PLANNING APPLICATION NUMBER:P12/0304

Type of approval sought	Outline Planning Permission
Ward	Belle Vale
Applicant	Mr John Carroll
Location:	LAND ADJACENT TO 1 & 2, FURNACE HILL, HALESOWEN, WEST MIDLANDS, B63 3LZ
Proposal	OUTLINE APPLICATION FOR THE ERECTION OF 3 NO. DWELLINGS (ACCESS, LAYOUT AND SCALE TO BE CONSIDERED) (RESUBMISSION OF REFUSED APPLICATION P11/0338)
Recommendation Summary:	APPROVE SUBJECT TO CONDITIONS

PROPOSED SITE LAYOUT 1:200

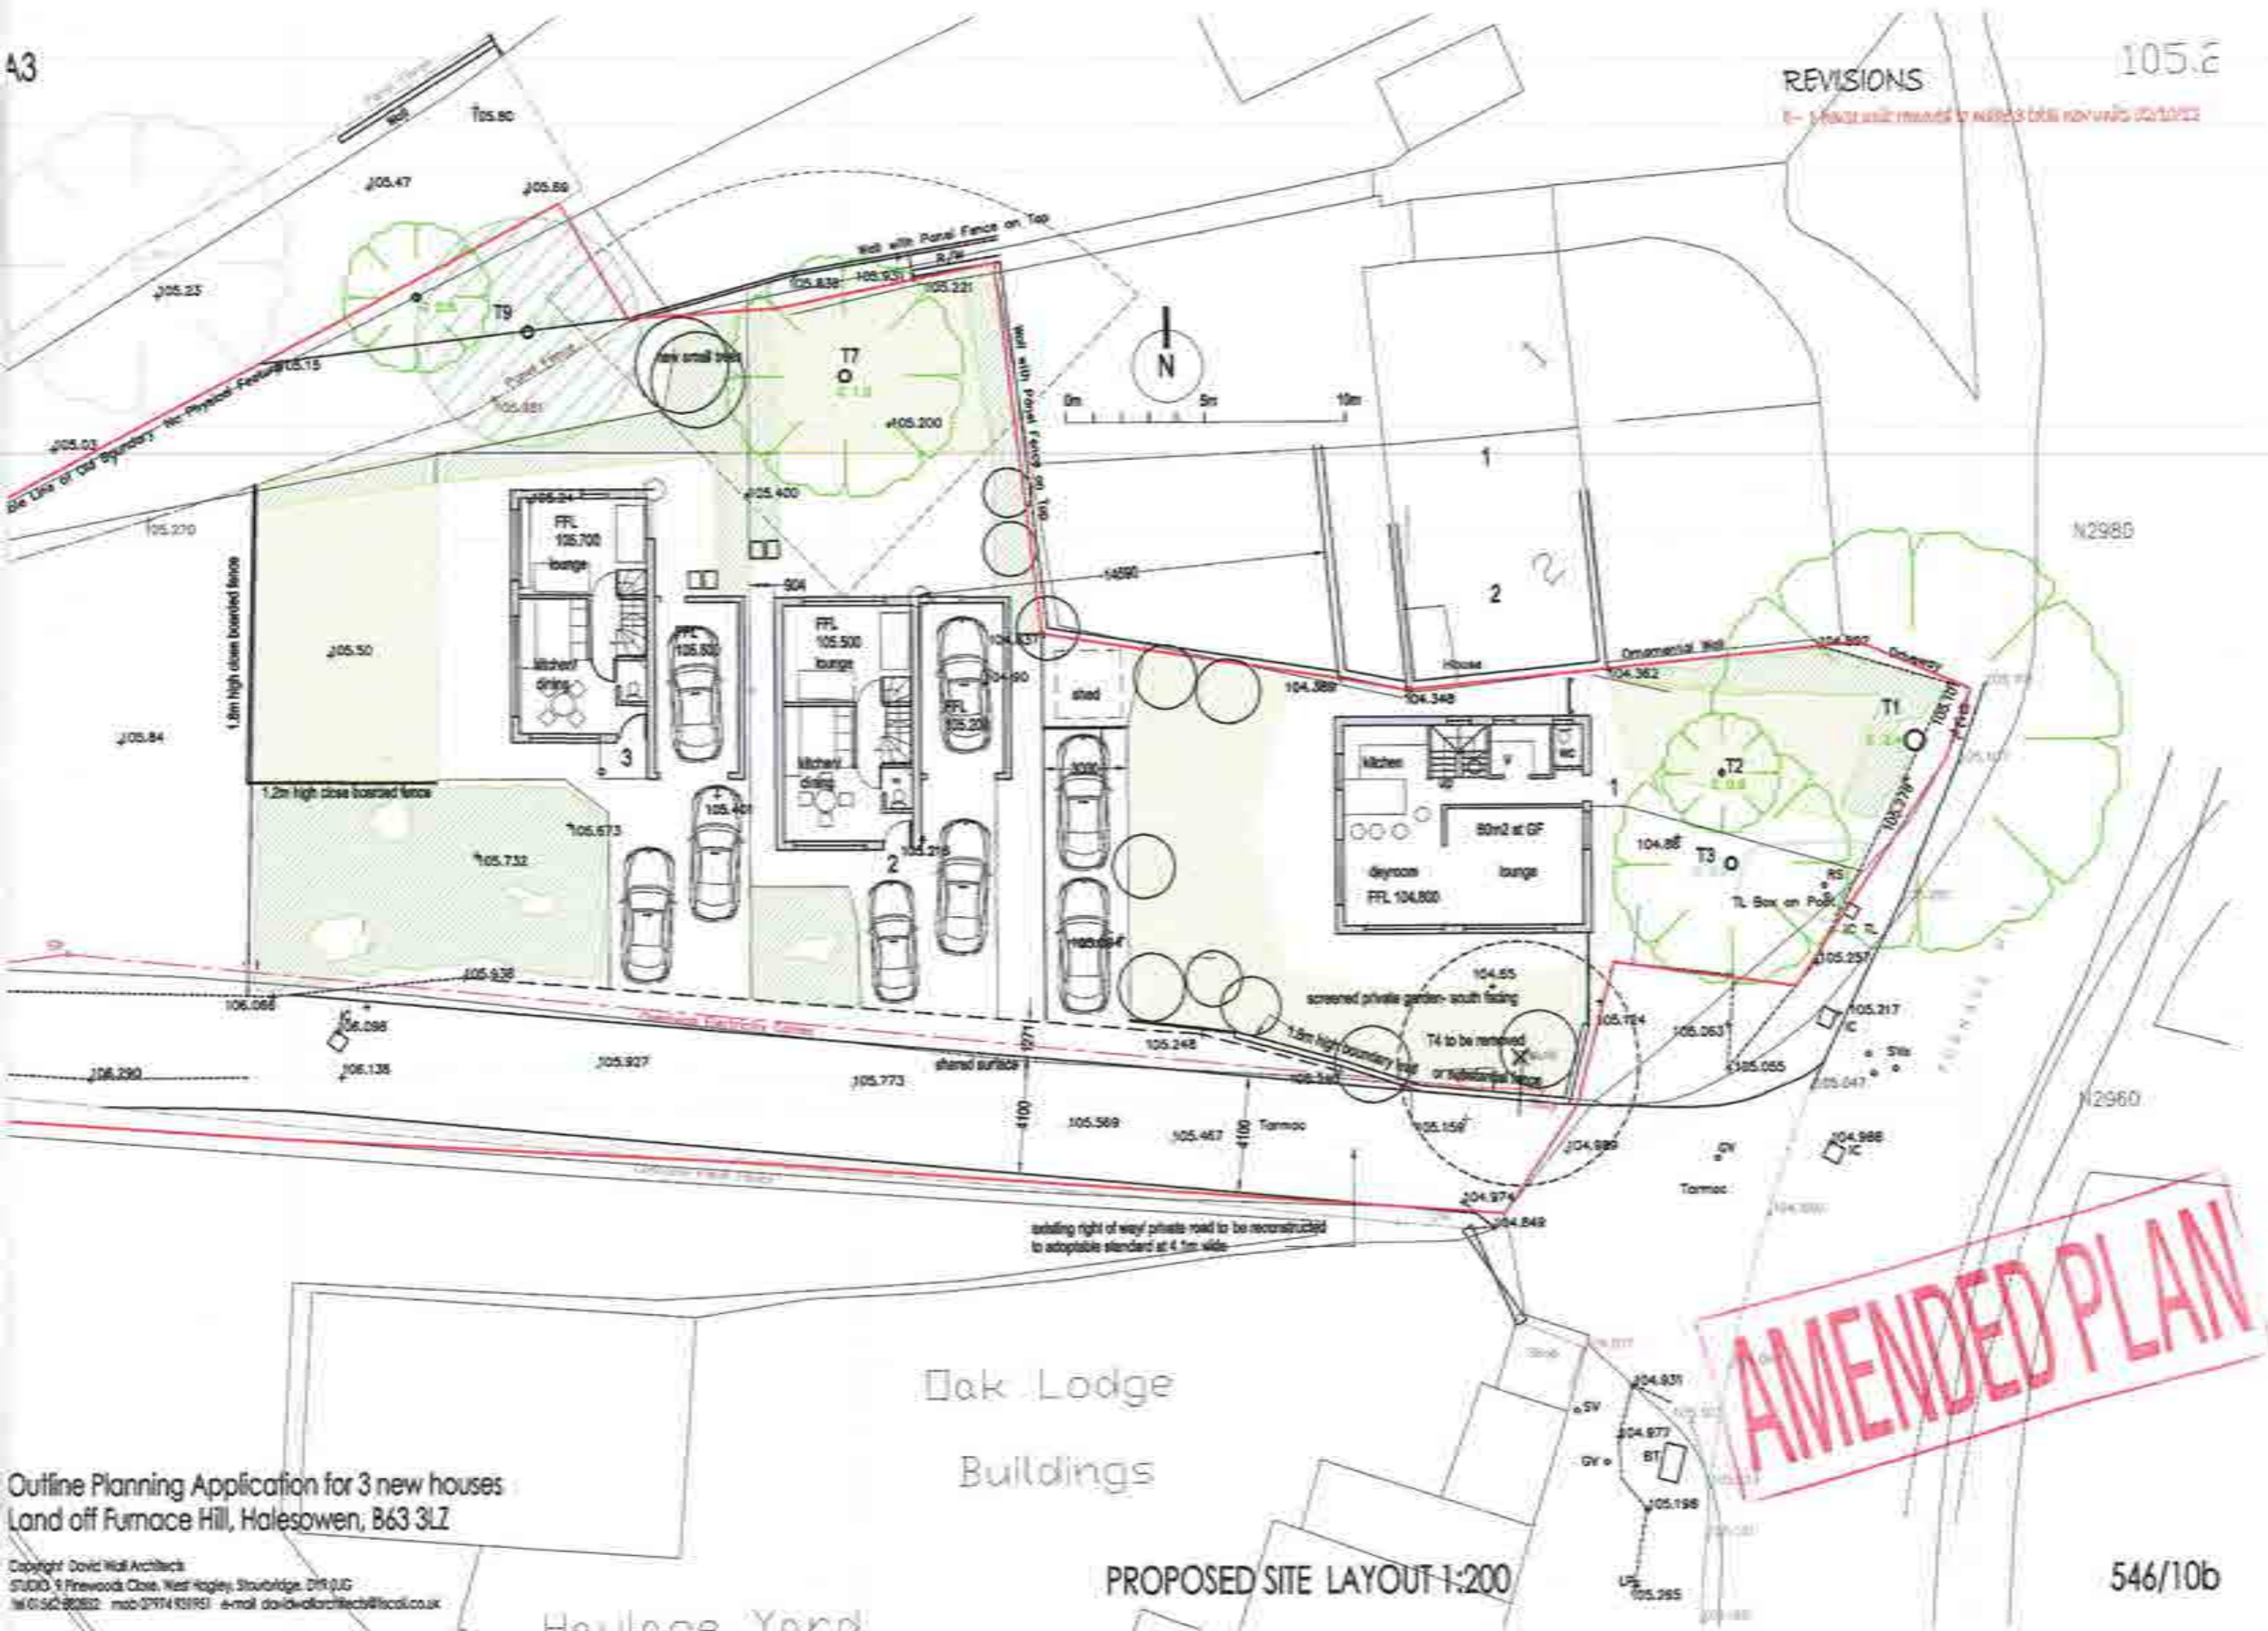
20. The proposed new building at the front of the site (plot 1) would be an appropriate 'end-stop' in terms of its siting and scale to the adjacent line of dwellings along Haden Hill Road, filling in a 'gap' between the side of No.2 Haden Hill Road and the Furnace Hill junction. A 1.8m high fence or wall is to be sited along part of the plot's boundary with the access road; given that it would be prominently sited within the development details of the proposed materials should be sought by condition to ensure that it would have an acceptable appearance.

21. The development of two new dwellings at the rear of the site (plots 2 and 3) provides the opportunity to improve its appearance, by removing an unsightly overgrown area and replacing it with buildings which are of an appropriate scale and siting. The proposal is also of benefit in that it would bring with it the opportunity to increase surveillance of the access road.

24. Although the site is at an elevated level above No.s 1 and 2 Furnace Hill the erection of the proposed buildings on plots 2 and 3 would not have any detrimental impact on outlook from those properties or lead to overshadowing given the distances involved and the relative siting of the houses (the side elevation of the house on plot 2 being approximately 14.5m from the rear of No.2 Haden Hill Road). The siting of the building on plot 1 would not have any harmful effect on outlook from the rear windows at No.2 Furnace Hill.

27. The proposed access road into the site will incorporate the existing public footpath which leads to Shelah Road. The submitted layout plan shows that a shared surface is to be provided and that the road will be constructed to an adoptable standard. The development will therefore allow for the unobstructed use of the right of way.
28. Parking provision for each of the houses is in accordance with the standards set out in the Parking Standards SPD and the development will not therefore lead to parking on the access road. The Group Engineer has not raised any concerns relating to potential conflicts between vehicles accessing/egressing the site and other vehicles or pedestrians. It is therefore considered that the proposal would not bring with it any adverse highway safety implications and does not contravene Saved UDP Policy DD4.

9. Prior to the commencement of development, details of the works for the disposal of foul and surface water drainage shall be submitted to and approved in writing by the Local Planning Authority. All works shall be completed in accordance with the approved details prior to the occupation of the dwellings hereby permitted.
10. The development hereby permitted shall be carried out in accordance with the following approved plan: 546/10b.
